Access Compliance Report

Public Rights-of-Way

(Curb Ramps)

Intersection ID: 19845	Main Street: CECILIA_LN	Cross Street: KELBURN_LN	Location: S
ADA ID: 0DE5C694C37C	Ramp Type: Perp	Initial Pass/Fail: Fail	Overall Compliance: No
			Severity Score: 21.25

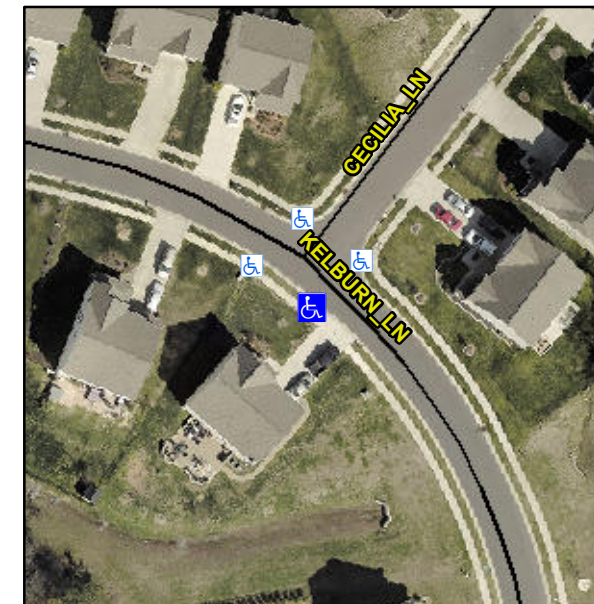
Not Found, R304.5.1, R304.2.2

Compliance	Description	Data	Compliance	Description	Data
N/A	Ramp Length (in)	47.0	No	Ramp Slope (%)	9.1
No	Ramp Width (in)	46.5	Yes	Ramp XSlope (%)	1.1
N/A	Flare Type LT	N/A	N/A	Flare Type RT	N/A
N/A	Flare Slope LT (%)	N/A	N/A	Flare Slope RT (%)	N/A
N/A	Flare Traversable LT?	N/A	N/A	Flare Traversable RT?	N/A
N/A	Landing Length (in)	N/A	N/A	DWS Provided?	N/A
N/A	Landing Width (in)	N/A	N/A	DWS Contrast?	N/A
N/A	Landing Slope (%)	N/A	N/A	DWS Length (in)	N/A
N/A	Landing X Slope (%)	N/A	N/A	DWS Full Width?	N/A
N/A	Landing Curb? (Y/N)	N/A	N/A	DWS Offset (in)	N/A
N/A	Shared Landing?	N/A			
N/A	Gutter Ponding?	N/A	N/A	Gutter Slope (%)	N/A
N/A	Gutter Lip Ht (in)	N/A	N/A	Gutter X Slope (%)	N/A
N/A	Painted X Walk1?	No	N/A	Painted X Walk2?	N/A
	X Walk 1 Direction	To NE		X Walk 2 Direction	N/A
N/A	X Walk 1 Width (in)	N/A	N/A	X Walk 2 Width (in)	N/A
	X Walk 1 Slope (%)	1.6		X Walk 2 Slope (%)	N/A
	X Walk 1 X Slope (%)	1.1		X Walk 2 X Slope (%)	N/A

Remove & Replace Entire Ramp.
